**SUSQUEHANNA STEAM ELECTRIC STATION  
PROPOSED AMENDMENT NO. 288 TO LICENSE NPF-14 AND  
PROPOSED AMENDMENT NO. 256 TO LICENSE NPF-22:  
REVISION TO TECHNICAL SPECIFICATION 3.8.1  
(UNIT 1 ONLY) AND FIGURE 4.1-2  
PLA-6042**

**Docket Nos. 50-387  
and 50-388**

#### **Technical Specification 3.8.1 and Figure 4.1-2**

**Figure 4.1-2**

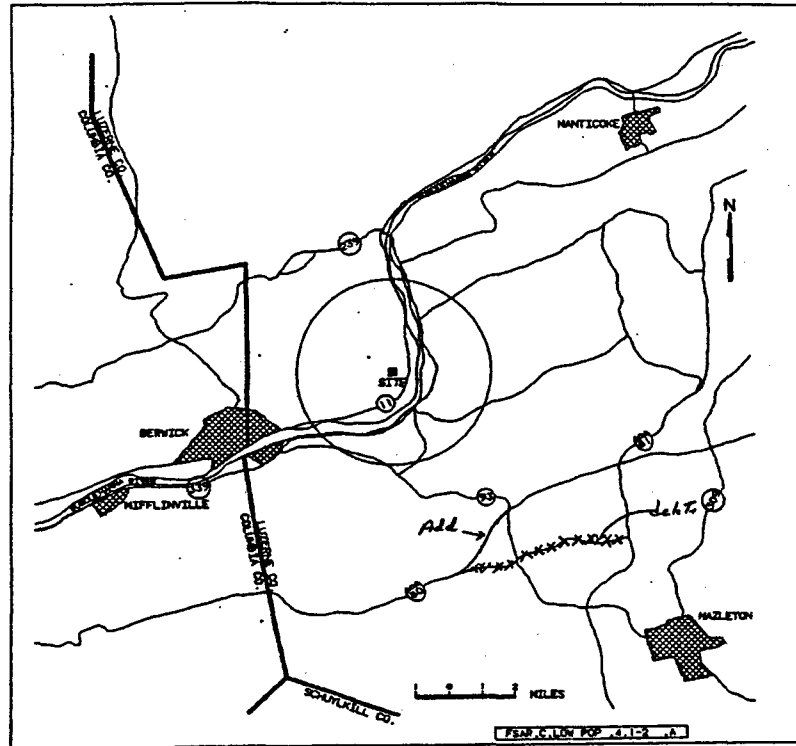
The proposed change revises the routing of Interstate Route 80 (I-80) on Figure 4.1-2. Figure 4.1-2 incorrectly shows that I-80 intersects with Interstate Route 81 (I-81) and becomes part of I-81.

### Change to Figure 4.1-2

**This change revises the routing of I-80 on Figure 4.1-2 of Units 1 and 2 Technical Specifications as follows:**

In 1998 during the conversion of the Technical Specifications to the Improved Technical Specifications, the routing of I-80 was inadvertently drawn incorrectly in Technical Specification Figure 4.1-2.
